APPLICATION NO.	FILING DATE	FIRST NAMED INVENTOR	ATTORNEY DOCKET NO.	CONFIRMATION NO.
10/747,716	12/29/2003	Kuo-Chang Yang	251702-1310	5874
24504	7590	09/19/2005		
THOMAS, KAYDEN, HORSTEMEYER & RISLEY, LLP 100 GALLERIA PARKWAY, NW STE 1750 ATLANTA, GA 30339-5948			EXAMINER CHANDRAN, BIJU INDIRA	
			ART UNIT 2835	PAPER NUMBER

Office Action Summary	Application No. 10/747,716	Applicant(s) YANG ET AL.	
	Examiner Biju Chandran	Art Unit 2835

DETAILED ACTION

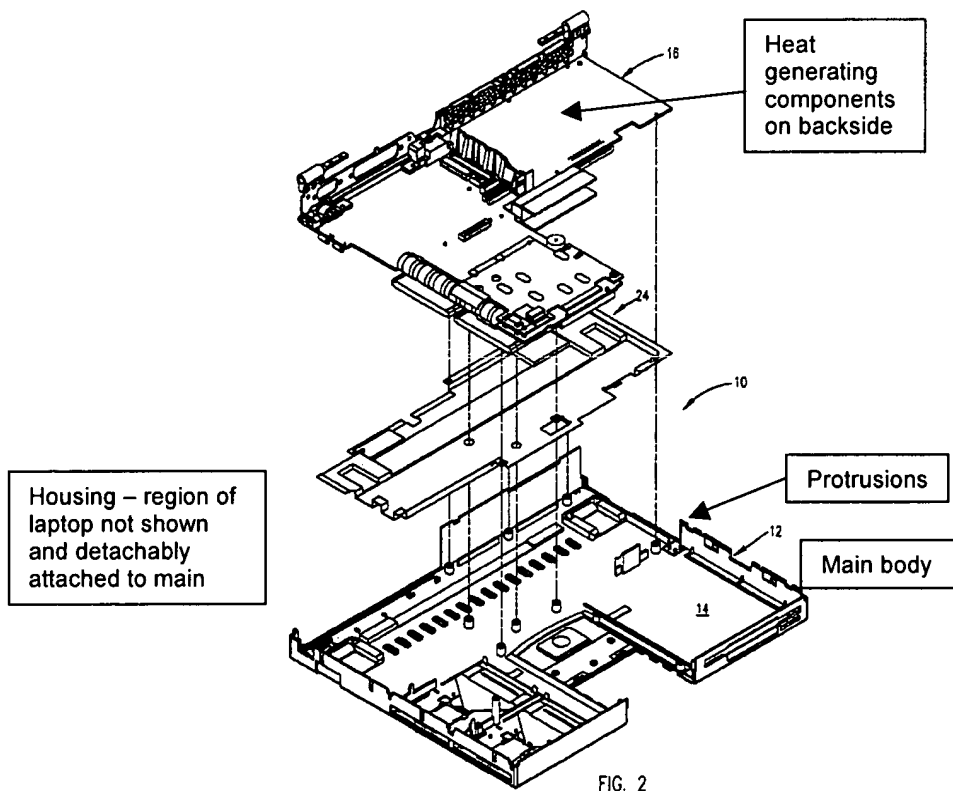
- Regarding claim 1, Jones et al. discloses an electronic device, comprising: a main body (12); a thermal insulation layer (44) (column 4, line 30) disposed on the inner surface of the main body; a conductive layer (46) fully covering the surface of the thermal insulation layer (column 3, line 41); an electrical insulation layer (48) partially covering the conductive layer (column 3, lines 55-60), leaving part exposed to dissipate heat from the electronic device. Jones et al. do not expressly disclose a hatch for the electronic device. Chuang discloses a hatch for an electronic device. At the time the invention was made, it would have been obvious to a person of ordinary skill in the art to incorporate the invention of Jones et al. in the hatch of the electronic device disclosed by Chuang, to reduce the cost and improve the effectiveness of EMI barriers (Jones et al., column 3, line 10-20).

- Regarding claim 7, Jones et al. further disclose a hole (40) in the main body.
- Regarding claim 8, Jones et al. further disclose protrusions on the edge of the main body.
- Regarding claim 9, Jones et al. further disclose the electronic device to be a notebook computer (column 2, line 65).

- Regarding claim 10, Jones et al. disclose a notebook computer having a housing (regions of laptop not shown in figure) comprising: a main body (12) detachably disposed on the housing; a thermal insulation layer (44) disposed on a side of the main body, wherein the side is adjacent to heat-generating components (22); a conductive layer (46) covering the surface of the thermal insulation layer (column 3, line 41); an electrical insulation layer (48) partially covering the conductive layer, leaving part of the conductive layer is exposed (column 3, line 55-60), and heat from the component is insulated by the thermal insulation layer. Jones et al. do not explicitly disclose a hatch for the electronic device. Chuang discloses a hatch for an electronic device. At the time the invention was made, it would have been obvious to a person of ordinary skill in the art to incorporate the invention of Jones et al. in the hatch of the electronic device disclosed by Chuang, to provide and an access port for the user to replace components without having to dismantle the electronic device.

- Regarding claim 16, Jones et al. further disclose a hole (40) in the main body.
- Regarding claim 17, Jones et al. further disclose protrusions on the edge of the main body.
- Regarding claim 18, Jones et al. further disclose that that the conductive layer is disposed between the electrical insulation layer and the thermal insulation layer (see figure 4, Jones et al.)
- Regarding claim 19, Jones et al. further disclose that that the electrical insulation layer is disposed between the component and the conductive layer (see column 3, lines 43-45, Jones et al.)
